Medical Device / Equipment ALERT: Field Action

Ref:MDB/A/2008/013

MODEL 3387, 3387S, 3389, AND 3389S DBS™ LEAD KITS - INSTRUCTIONS FOR USING THE LEAD CAP.

**Model 3387, 3387S, 3389, and 3389S Deep Brain Stimulation (DBS™) Lead Kits
Instructions for Using the Lead Cap**

Figure 27: Hold setscrew connector block between thumb and forefinger.

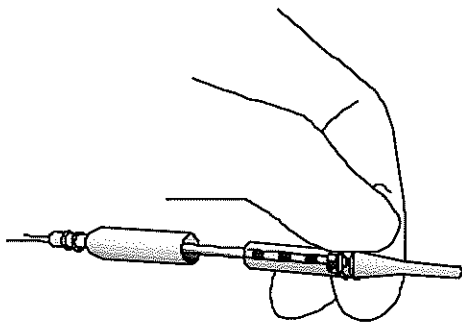
3. Align the number 3 lead contact with the setscrew connector block (Figure 26).
4. Hold the setscrew connector block firmly between thumb and forefinger to prevent rotation (Figure 27).

Figure 28: Tighten setscrew.

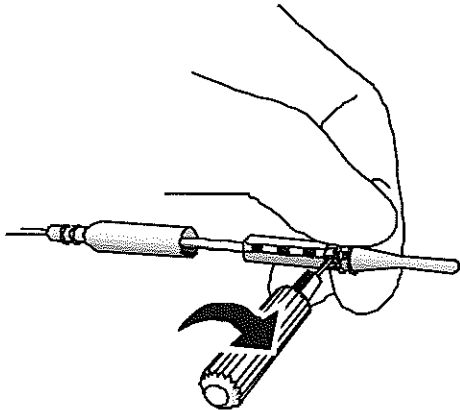
5. Tighten the single setscrew in the setscrew socket on the number 3 lead contact by turning it clockwise with the hex wrench provided (Figure 28). Tighten the setscrew until it touches the contact; then continue tightening for a maximum of 1/4 turn only.

Caution: Excessive torque on setscrew may damage lead contact.

Figure 29: Slide connector boot over lead cap.

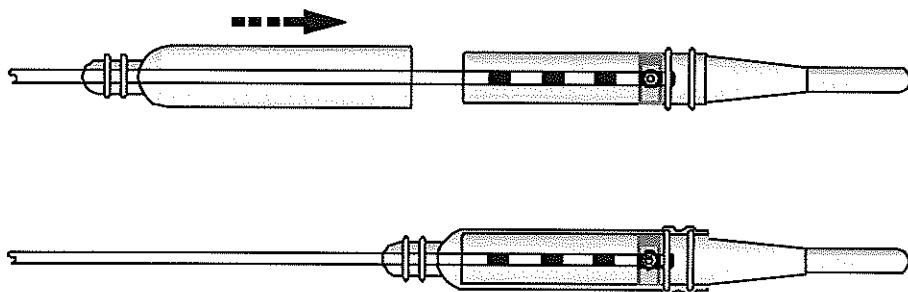
6. Slide the connector boot over the lead cap (Figure 29).

Note: If it is difficult to position the boot, only sterile water may be used as a lubricant.

Figure 31: Lead in subgaleal pocket.

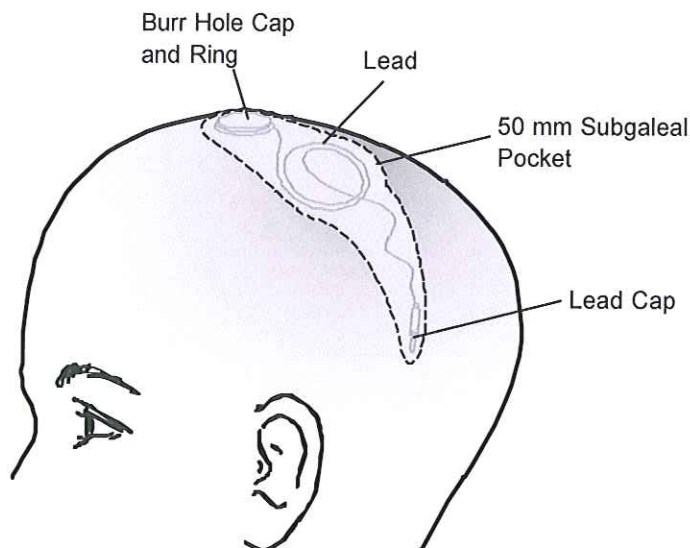
8. Use blunt dissection to create a 50 mm diameter subgaleal pocket and a path to the desired lead-extension connection site (Figure 31).

9. Deliver the capped end of the lead to the desired temporary location (Figure 31).

10. In the subgaleal pocket, coil excess lead in a circle greater than 25 mm in diameter (Figure 31).
Avoid bending or kinking the lead.

Figure 32: Make incision to expose lead and lead cap.

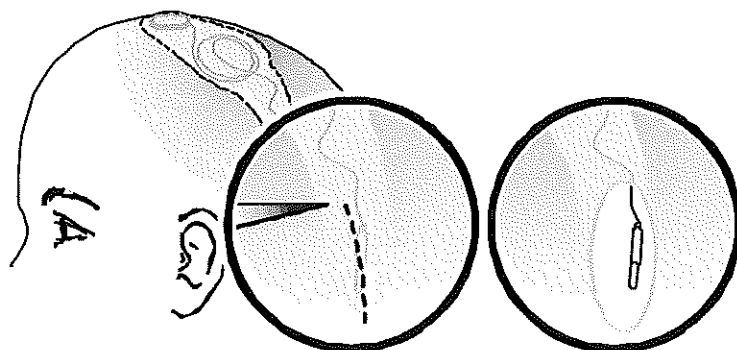
2. Make an incision sufficient to expose the lead and lead cap. Allow room to hold the lead firmly when accessing the lead cap and when connecting the lead to the extension (Figure 32).

1. Be extremely careful when using sharp instruments around the lead body to avoid nicking or damaging the lead.
2. Avoid pulling the lead cap out of the tissue to prevent excess stress on the lead. If more slack is needed, gently grasp the lead body and lift the lead cap out of the tissue. Do not bend, kink, stretch, or twist the lead body when accessing the lead cap.

Figure 33: Cut distal suture over lead end of connector boot.

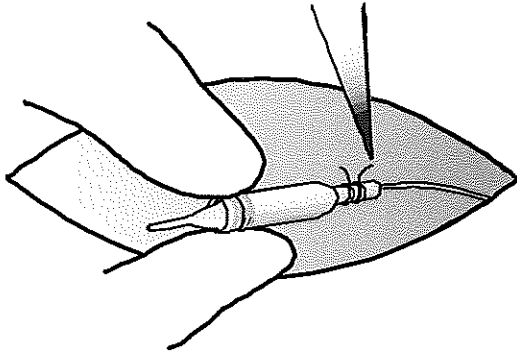
3. Cut the distal suture over the lead end of the connector boot (Figure 33).

Caution: Do not cut the lead when removing the suture. Cutting the lead's insulation can result in loss of stimulation and lead failure.

Figure 34: Cut connector boot to expose setscrew.

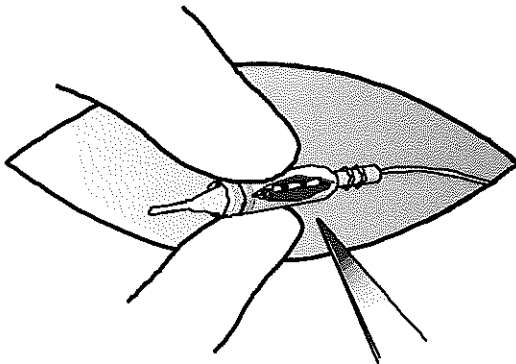
4. Cut the connector boot over the lead cap to expose the setscrew (Figure 34).

Figure 35: Hold setscrew connector block between thumb and forefinger.

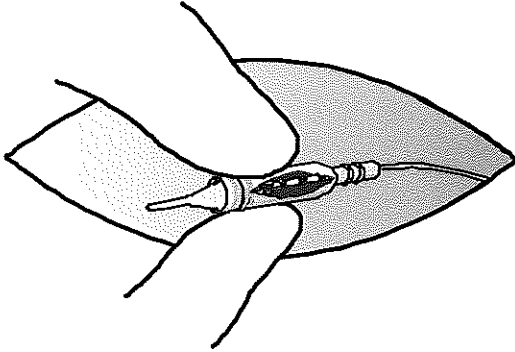
5. Hold the setscrew connector block firmly between thumb and forefinger to prevent rotation (Figure 35).

Figure 36: Loosen setscrew.

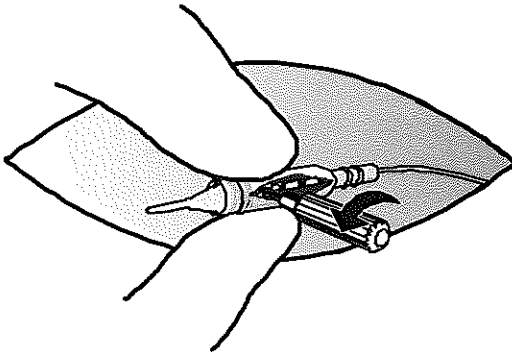
6. Using the hex wrench, loosen the setscrew in the setscrew connector by turning the wrench counterclockwise (approximately one turn) (Figure 36).

Figure 37: Remove lead from setscrew connector block.

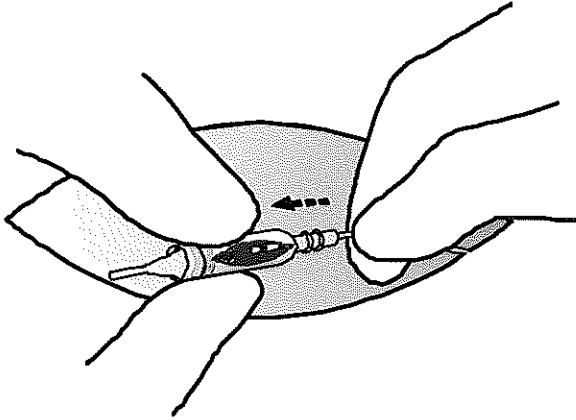
7. Stabilize the lead and gently remove the lead from the setscrew connector block (Figure 37).

Caution: If resistance is felt when removing the lead from the lead cap, loosen the setscrew slightly to ensure that it clears the lead contact. Avoid disengaging the setscrew. Inspect the lead contact for damage (flattening or stretching of lead) if resistance was felt prior to removal.

Figure 38: Withdraw lead cap and connector boot.

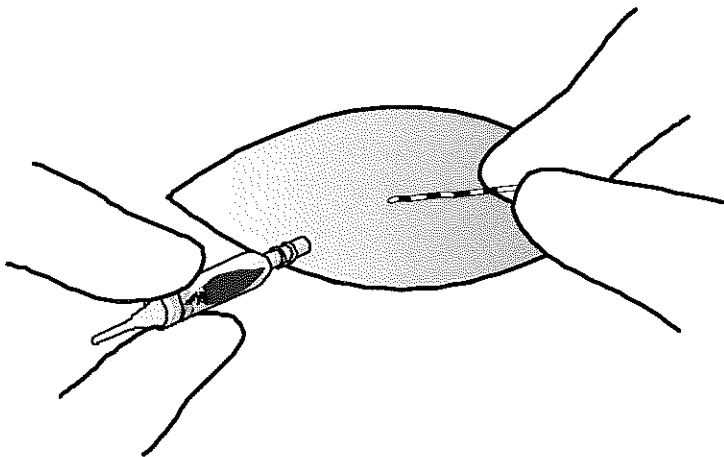
8. Withdraw the lead cap and connector boot through the incision and discard (Figure 38).
